**7, 15, 25R, 29 and 39 Queens Quay East – Official Plan and Zoning Amendment – Supplementary Report**

<b>Date:</b>	January 5, 2012
<b>To:</b>	Toronto and East York Community Council
<b>From:</b>	Director, Community Planning, Toronto and East York District
<b>Wards:</b>	Ward 28 – Toronto Centre-Rosedale
<b>Reference Number:</b>	10 147083 STE 28 OZ

Attachment 1: Site Plan  
Attachment 2: Roof Plan  
Attachment 3: North Elevation  
Attachment 4: West Elevation – Building G  
Attachment 5: East Elevation – Building G  
Attachment 6: South Elevation

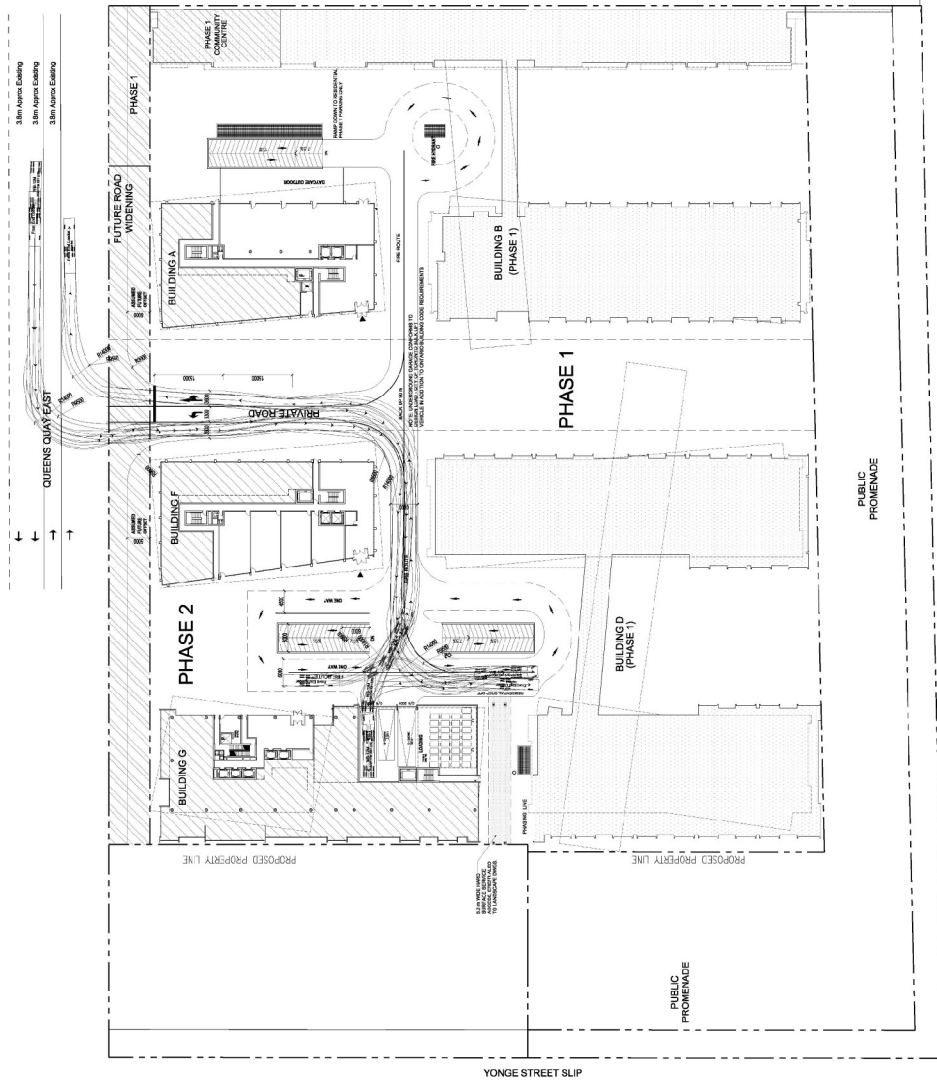
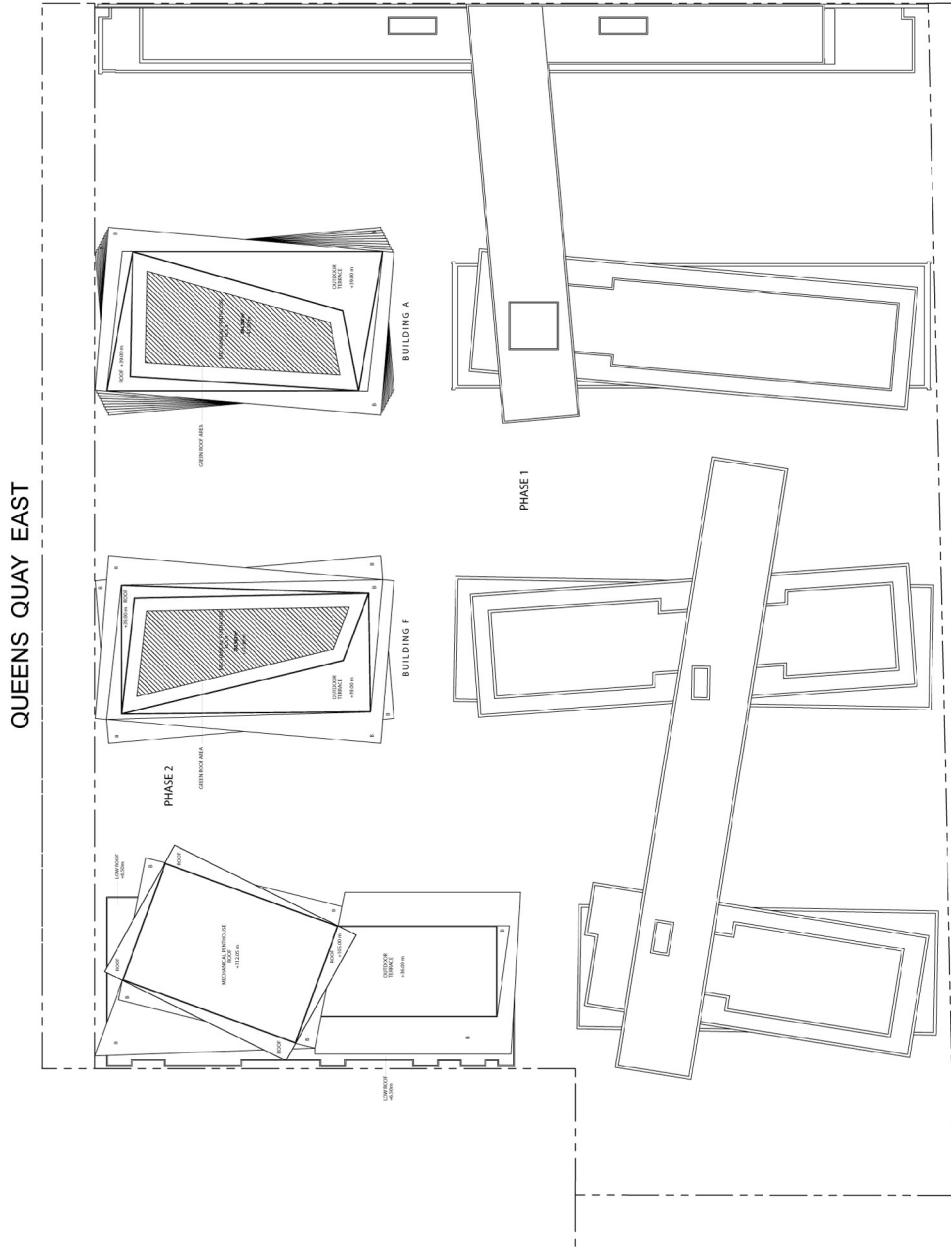
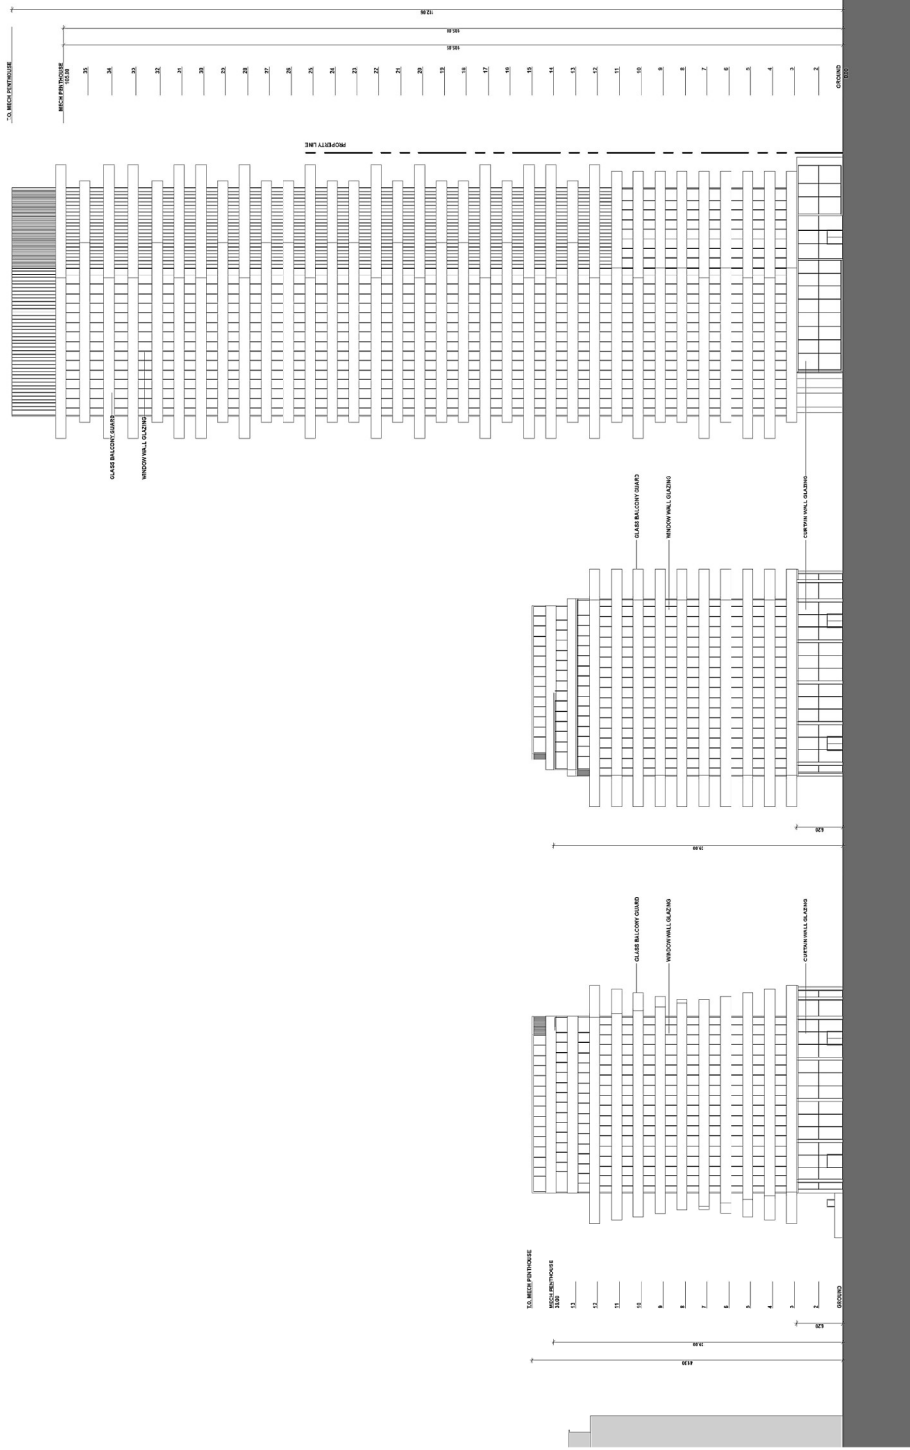
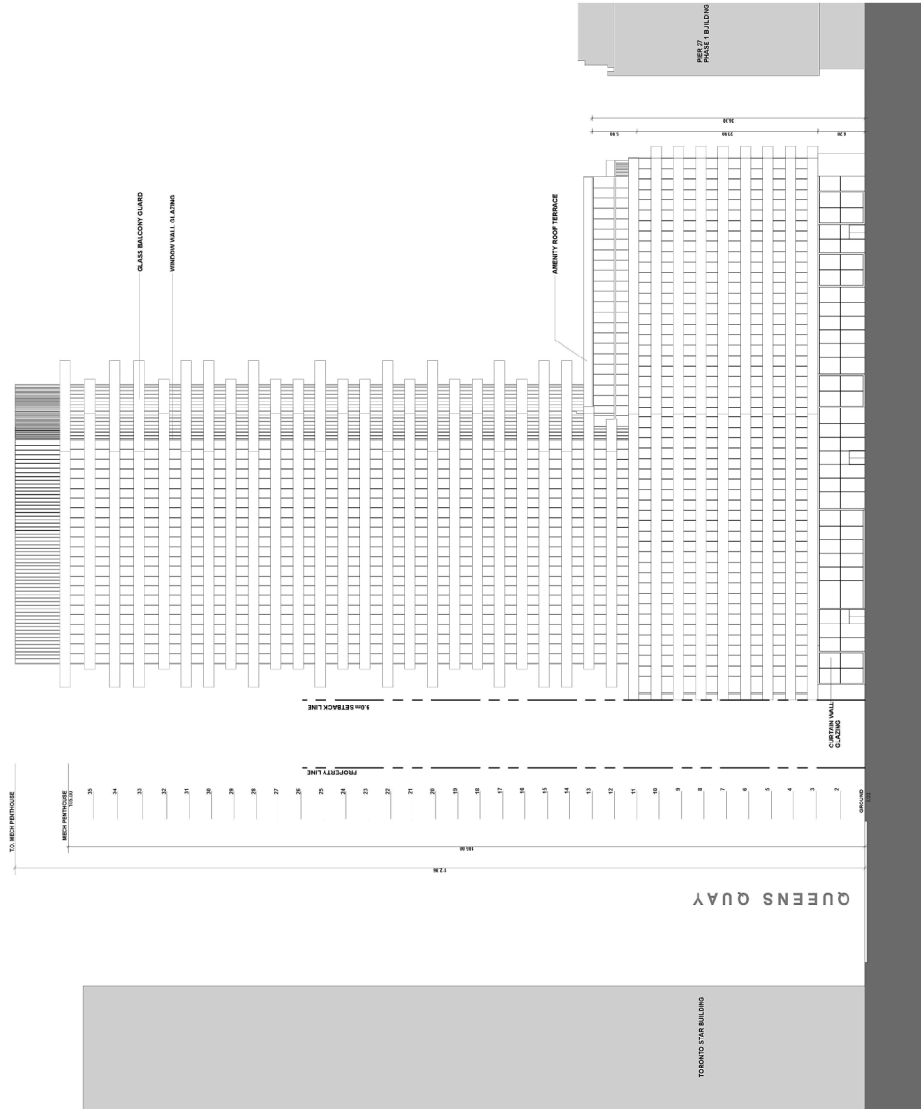
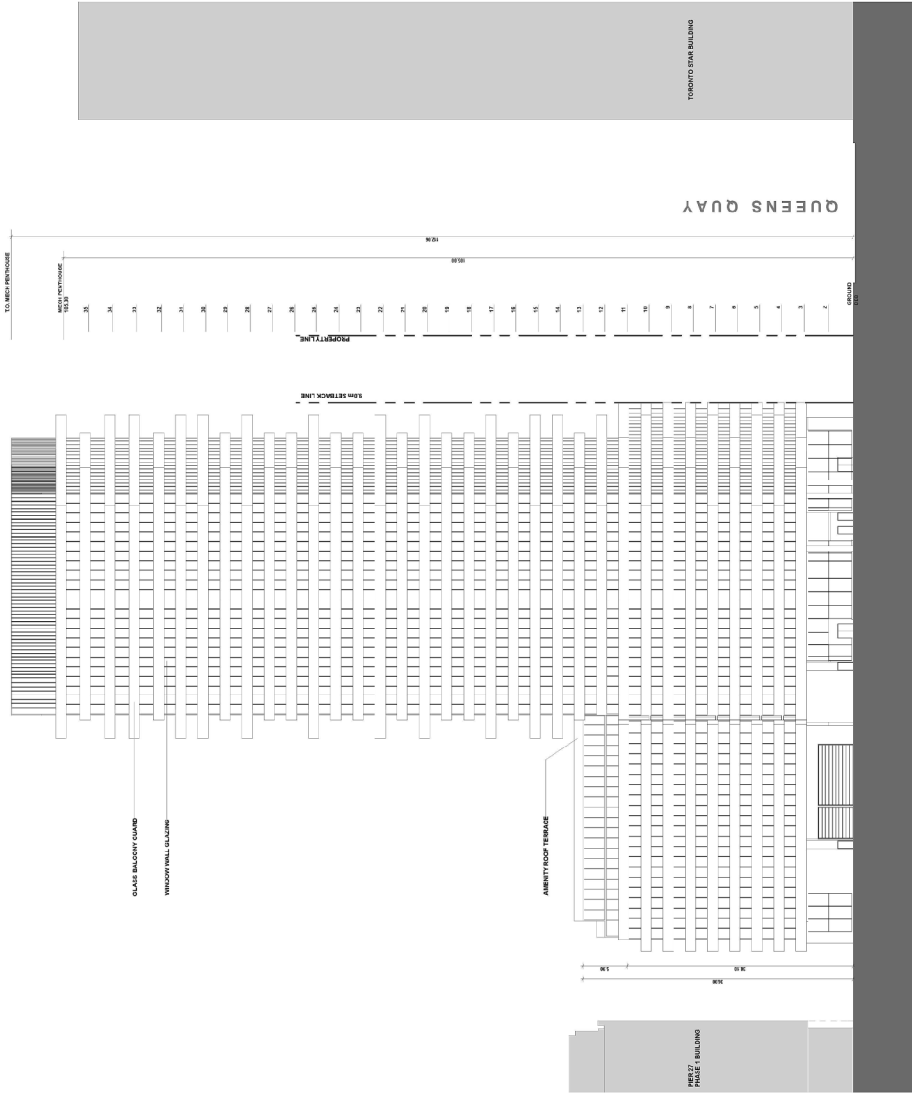
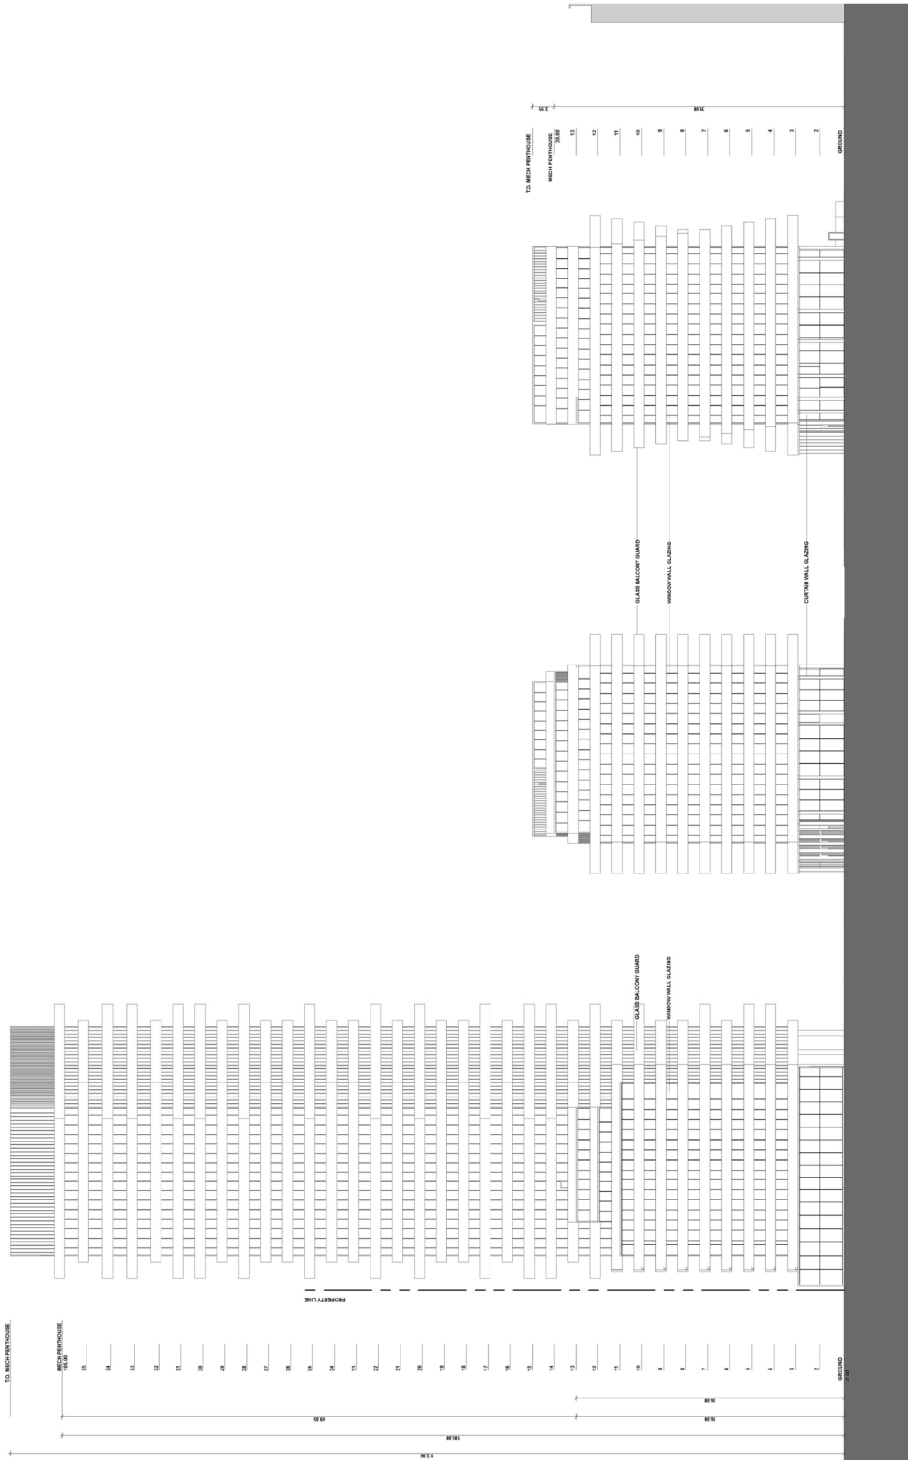
The primary design change is a 20-degree rotation of the northerly portion of the west tower (Building G), which continues to have a height of 35 storeys and sits above a 12-storey podium (See Attachments 1-6: Site Plan, Roof Plan and Elevations). Previously, the podium and tower shaft were rectangular and aligned in a north-south direction. The revised scheme rotates the north half of the building 20 degrees to the east beginning at the third floor and extending up to the mechanical penthouse. Similar to the previous scheme, the angles of the terraces and balconies projecting from the exterior walls provide architectural interest and articulation to the tower.

The rotation of the tower portion of Building G, while maintaining its floor plate size at approximately 697 square metres, continues to achieve the same urban design objectives as the original proposal. The proposal remains consistent with applicable design criteria set out in the City's Tall Building Design Guidelines.

The applicant has indicated the principal reason for the rotation of Building G is to address noise mitigation measures. The applicant advises that the revised scheme provides for additional buffering of the proposed residential development from the abutting Redpath industrial use to the east and minimizes adverse impact on the ability of Redpath to conduct existing operations and to expand, as required by the site-specific Official Plan policies. The evaluation of how the revised proposal meets the environmental guidelines for noise, vibration, dust and air quality is under review and, following Council's June 14 and 15, 2011 decision regarding the approval of the Official

The proposed tower rotation is acceptable from a built form and massing perspective, subject to any amendments required by the Chief Planner to address noise, vibration and air quality issues, as peer reviewed on behalf of the City.
